# Access Compliance Report Public Rights-of-Way (Curb Ramps)

Intersection ID: 44871	Main Street: CONLAN_CR	Cross Street: HUFFINES_LN	Location: SW
ADA ID: 1FB9694CF061	Ramp Type: BlendTrans1	Initial Pass/Fail: Fail	Overall Compliance: No Severity Score: 33.75

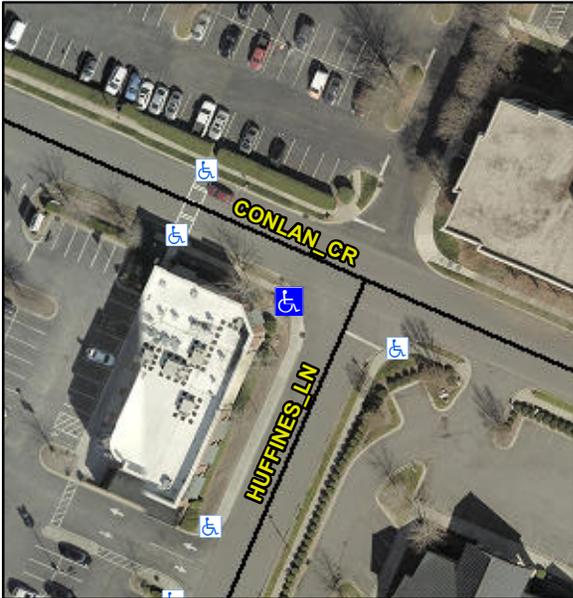
PROW/ADA:  
**Not Found, R304.5.1, R304.5.3**

Compliance	Description	Data	Compliance	Description	Data
N/A	Ramp Length (in)	59.0	Yes	BlendTrans Slope (%)	3.3
No	Ramp Width (in)	43.0	No	BlendTrans XSlope (%)	14.2
N/A	Flare Type LT	N/A	N/A	Flare Type RT	N/A
N/A	Flare Slope LT (%)	N/A	N/A	Flare Slope RT (%)	N/A
N/A	Flare Traversable LT?	N/A	N/A	Flare Traversable RT?	N/A
N/A	Landing Length (in)	N/A	N/A	DWS Provided?	N/A
N/A	Landing Width (in)	N/A	N/A	DWS Contrast?	N/A
N/A	Landing Slope (%)	N/A	N/A	DWS Length (in)	N/A
N/A	Landing X Slope (%)	N/A	N/A	DWS Full Width?	N/A
N/A	Landing Curb? (Y/N)	N/A	N/A	DWS Offset (in)	N/A
N/A	Shared Landing?	N/A			
N/A	Gutter Ponding?	N/A	N/A	Gutter Slope (%)	N/A
N/A	Gutter Lip Ht (in)	N/A	N/A	Gutter X Slope (%)	N/A
N/A	Painted X Walk1?	No	N/A	Painted X Walk2?	No
	X Walk 1 Direction	To SE		X Walk 2 Direction	To N
	X Walk 1 Width (in)	N/A		X Walk 2 Width (in)	N/A
	X Walk 1 Slope (%)	4.7		X Walk 2 Slope (%)	0.2
	X Walk 1 X Slope (%)	3.2		X Walk 2 X Slope (%)	2.6

N/A	Ramp inside XWalk1?	N/A	N/A	Ramp inside XWalk2?	N/A
	Road Slope (%)	4.2		Clear Space?	N/A
	Road X Slope (%)	0.2	N/A	Clear Space to XWalk (in)	N/A
N/A	Any Obstructions?	N/A	N/A	Storm Grate/Utility Hazard?	N/A
	Obstruction Type			Storm Grate/Utility Type	
		N/A			N/A
Yes	Surface Condition? (G/P)		Yes		Good
No	Curb Slope (%)		No		13.7

Possible Solutions:  
**Remove & Replace Curb Ramp With Two New Directional Ramps or Equivalent.**
